# City of Hurricane

## AGENDA

### OF A MEETING OF THE HURRICANE CITY PLANNING COMMISSION

Thursday, December 12, 2019

LEGEND

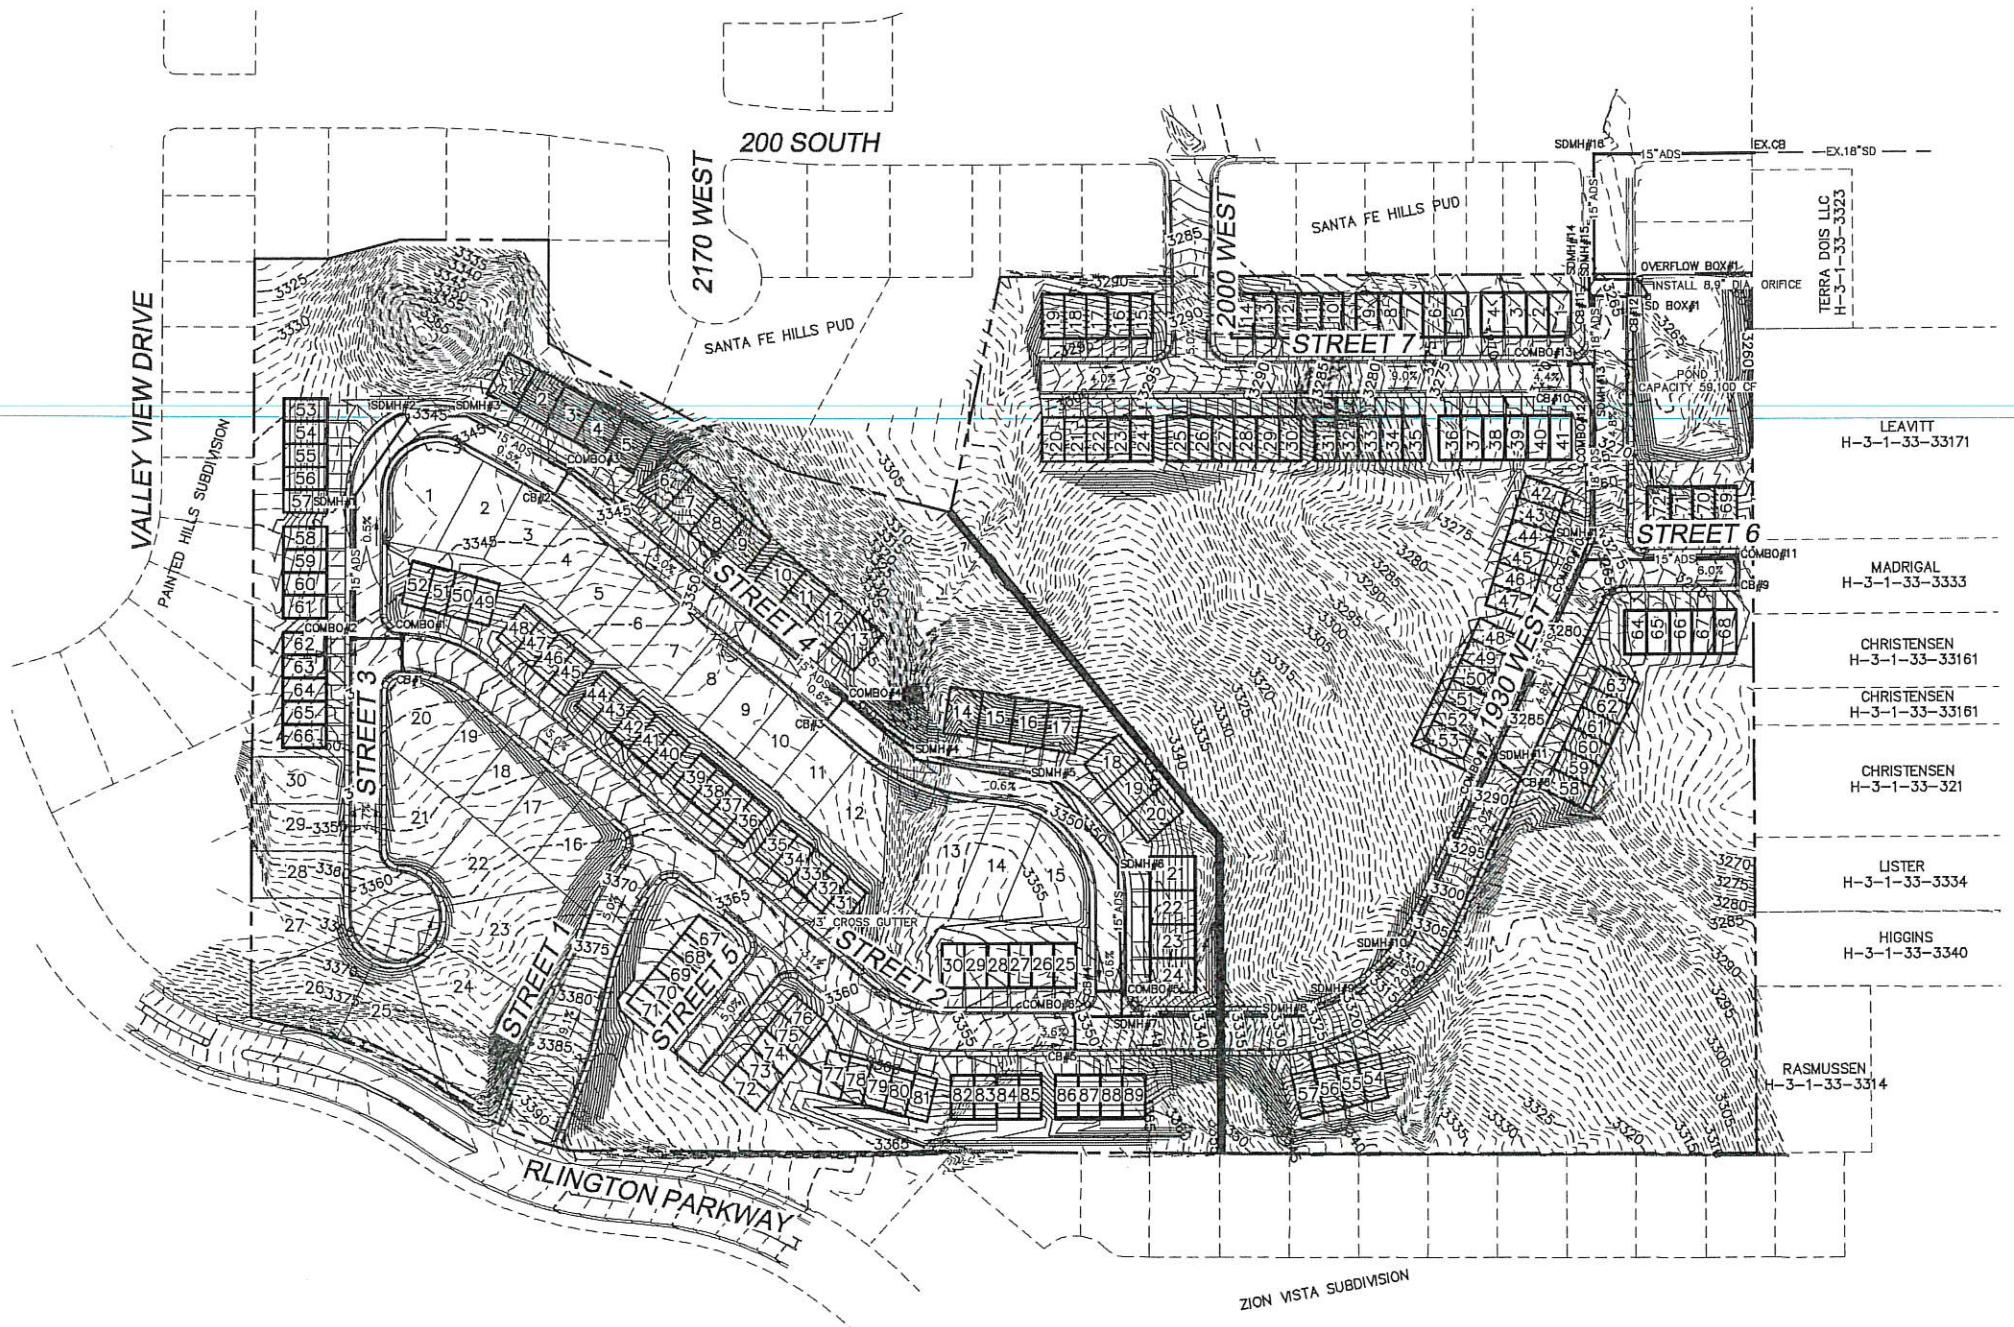
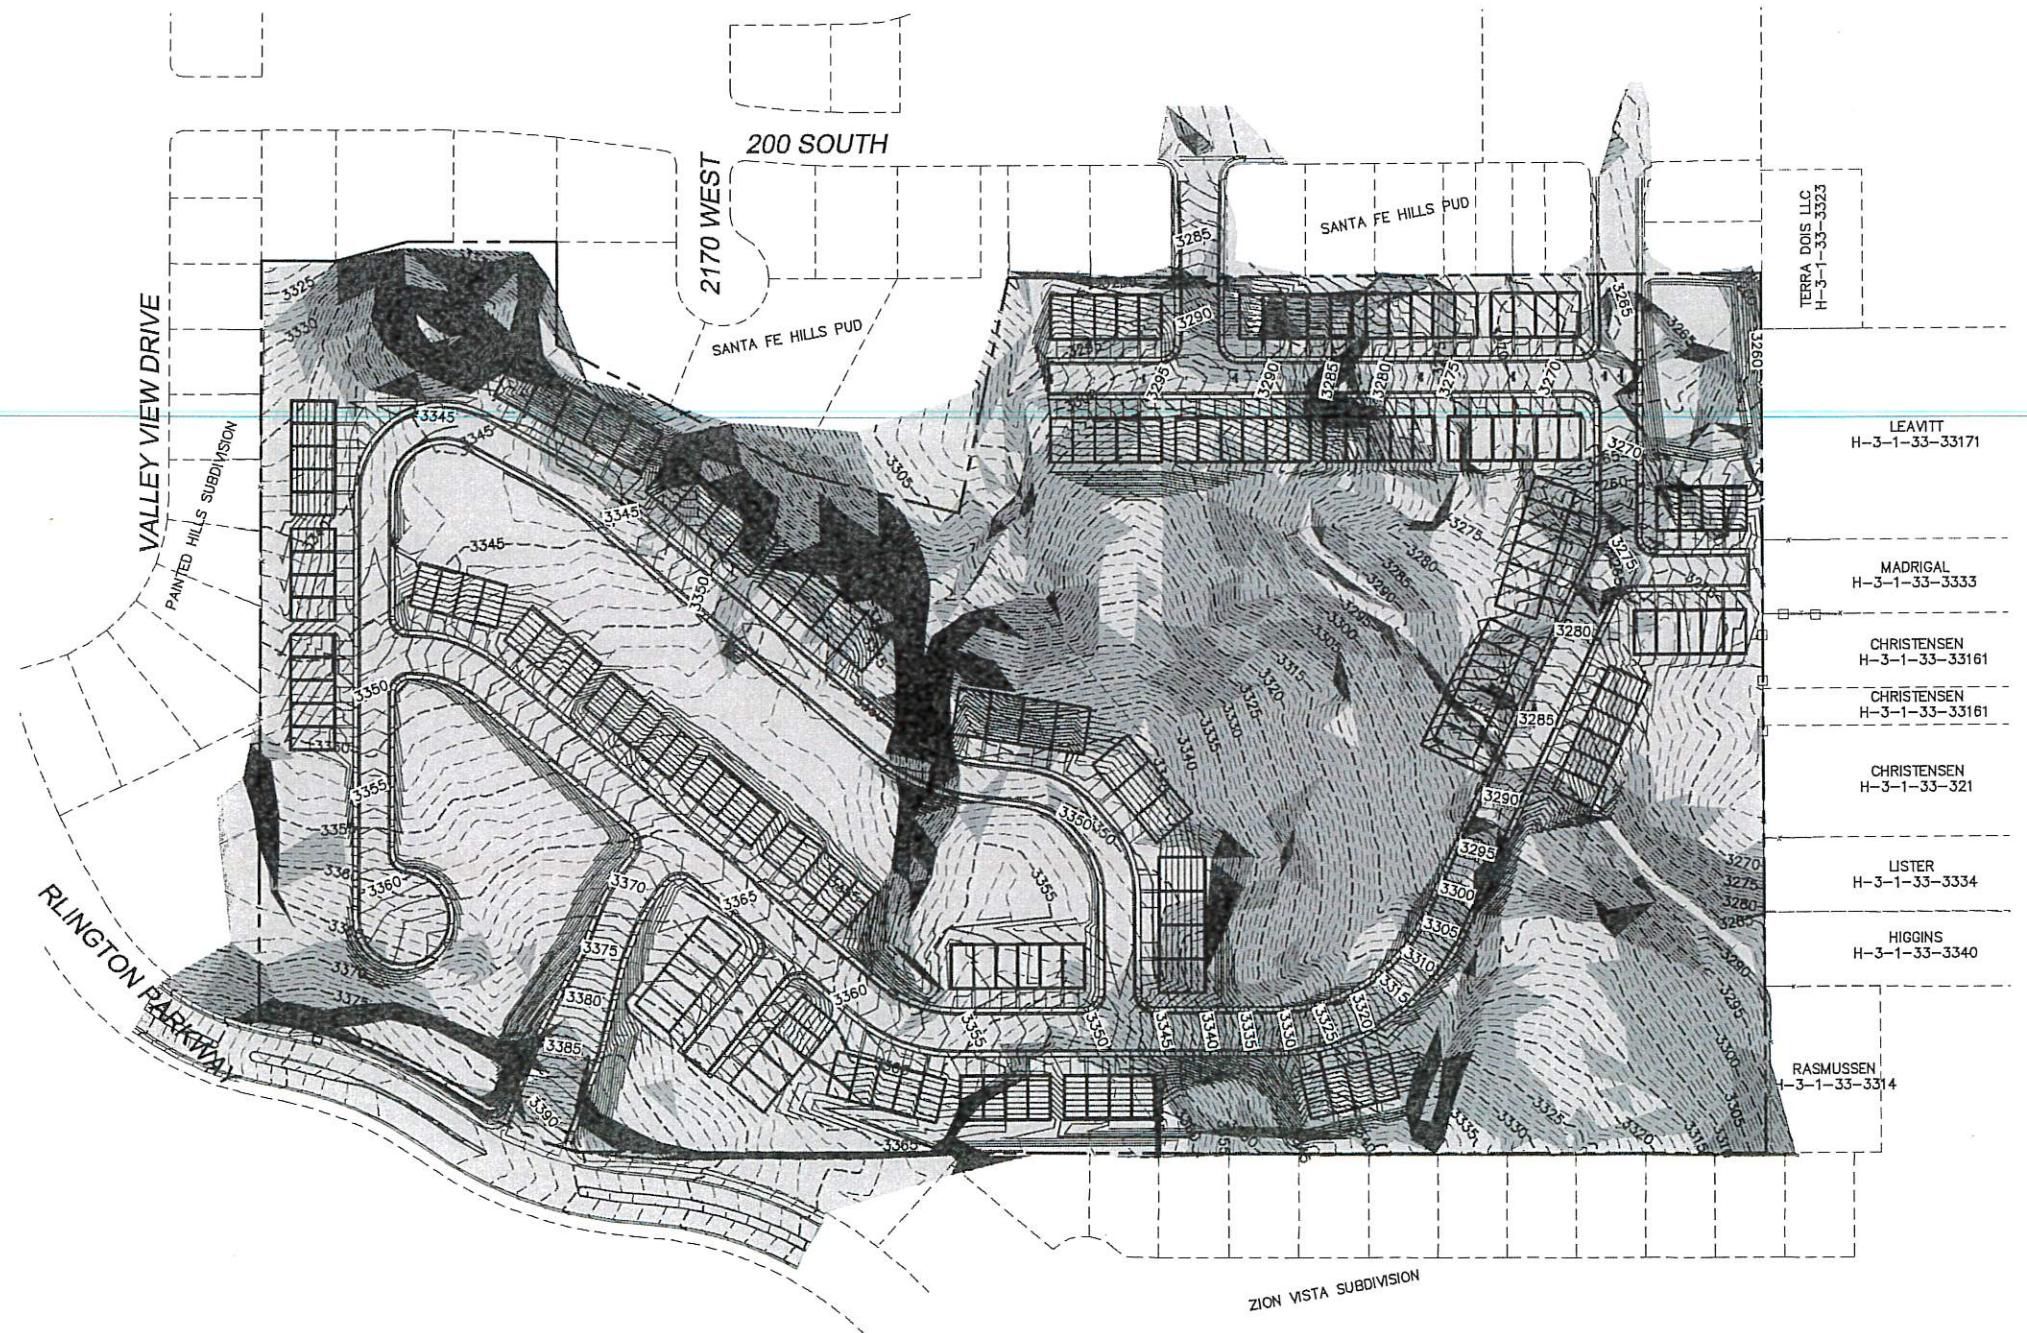
5. Length of the cul-de-sac on Street 3 does not appear to meet standards
6. Streets 6 and 7 are blunt dead ends with no turn around shown.
7. Drainage study is preliminary and final study will be required with construction drawings.
8. Phasing plan shows too many units on a single access in each phase. Fire Code and City access standards must be met.
9. It is not clear if the knuckle shown in Phase 3 meets Fire Code standards.
10. Design for natural gas must be submitted with construction drawings.
11. A traffic study may be required.

4. A reasonable distance has been provided between the single family homes in Painted Hills and Sante Fe Hills and the units in this project.
5. Lot sizes on the single family lots range from 11,942 sq. ft. to 4,500 sq. ft. This is a PDO so there are no minimum lot sizes. Grading plans will determine what portion of the lots will be usable. Final site plan should show a building envelope for review.

6. The following section of the code appears to still not be met, though an exception is allowed under 10-24-3G. *10-24-6: HILLSIDES AND RIDGE AREAS; GENERAL DEVELOPMENT STANDARDS: A. Unbuildable Slopes: Except as may be allowed by an exception as set forth in subsection 10-24-3G G. Exceptions: Exceptions to the provisions of this chapter may be granted by the city council upon recommendation from the planning commission when:*  
*1. An alternative solution is proposed for the protection of the sensitive land, based on sound and generally accepted engineering and land development principles, and said alternative will result in equal or better protection than development under the standards of this chapter; and is consistent with the purposes of this chapter. The alternative shall also be consistent with the general plan policies affecting sensitive lands; of this chapter, slopes of thirty percent (30%) or greater shall be undisturbed. Such areas shall be designated as a nonbuildable area if part of a residential lot, or at the election of the owner, these slopes may be offered to the city or a duly created nonprofit conservation organization. Slopes of thirty percent (30%) or greater, if included within a lot, shall not be considered as lot area contributing to the minimum area required in subsection B of this section.. The submitted plan shows areas of 30% or greater disturbed to create pads for Units 1,2, 6,7,8,12,13,14, 31,32, and 33. This is approximately 7% of the total number of townhome units. Commissioners should decide how to handle this section.*

7. It is clear the Sensitive Lands Code was written with single family lots in mind so consideration should be given to the different nature of a townhome project which results in less overall disturbance. This project leaves over 49% of the total property as common open space but without the grading plan it is unclear how much will be disturbed.

8. It appears the lot transfer calculations allowing bonuses for transferring lots off slopes and granting density bonuses might be a little generous for the developer, as many of the units are not completely off the 10% and greater slopes. The Planning Commission can determine if this is a reasonable application of this portion of the code.

**Recommendation:** Staff recommends the Planning Commission send a recommendation of approval to the City Council after making a determination on whether or not the units on the 30% slope meet any standards to be recommended for an exception. The motion should include language requiring compliance with all JUC requirements.
